Office Action Summary

10/756,877

BUSKE ET AL.

Addendum B

FIG. 2

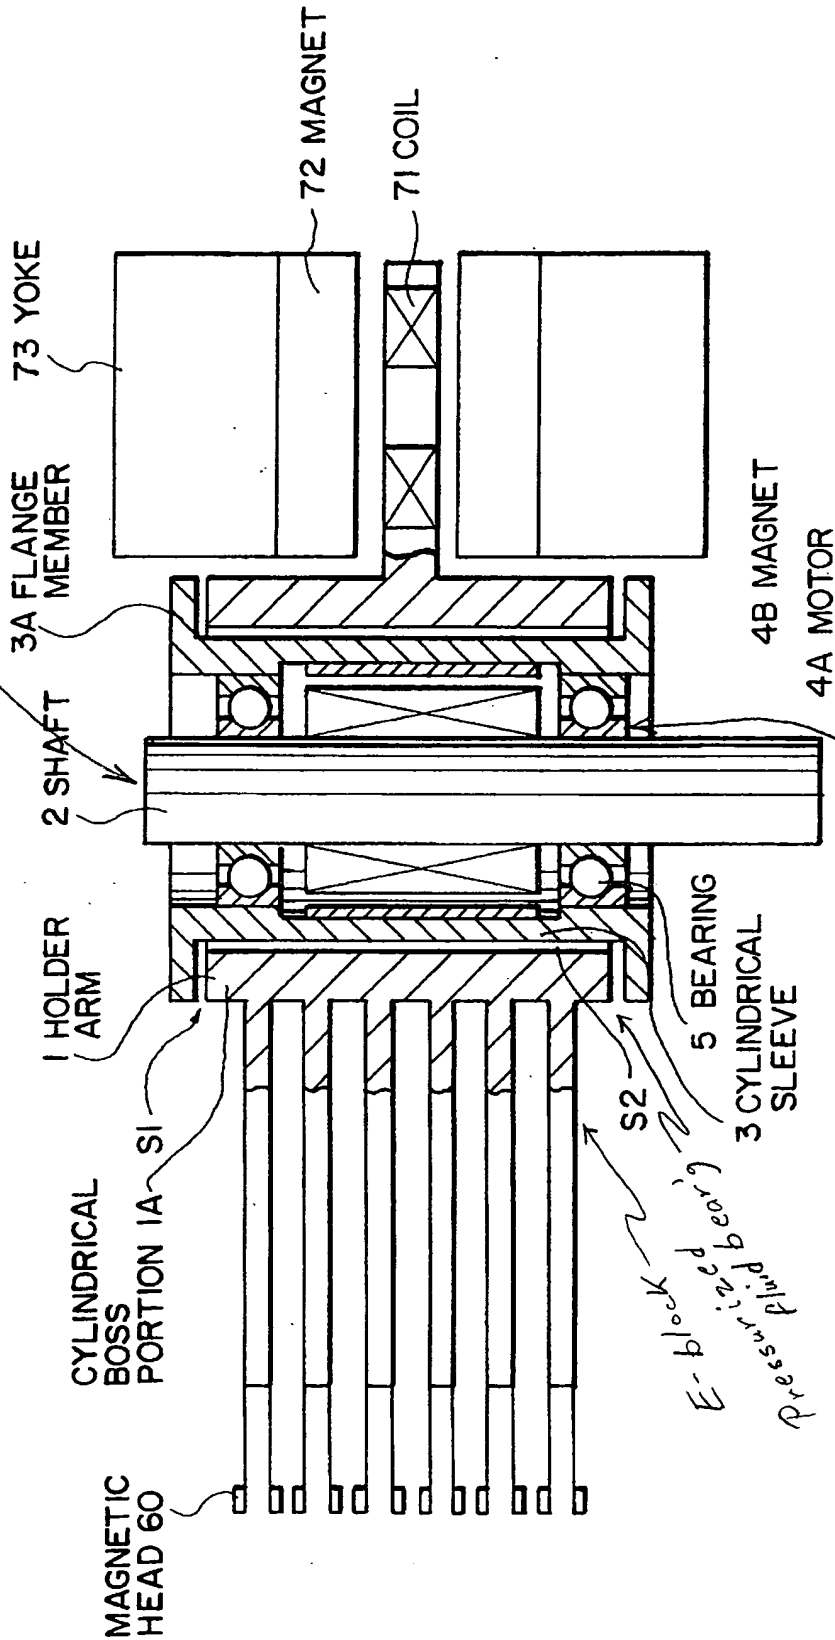
4. Claims 22-25 are rejected under 35 U.S.C. §102(b) as being anticipated by Sanada.

See Fig. 2. Note, to the extent claimed and understood, the structure as shown in Addendum B reads on and performs to the same degree as claimed; e.g. note that Sanada in col.2, line 54, documents that his fluid bearing system is pressurized.
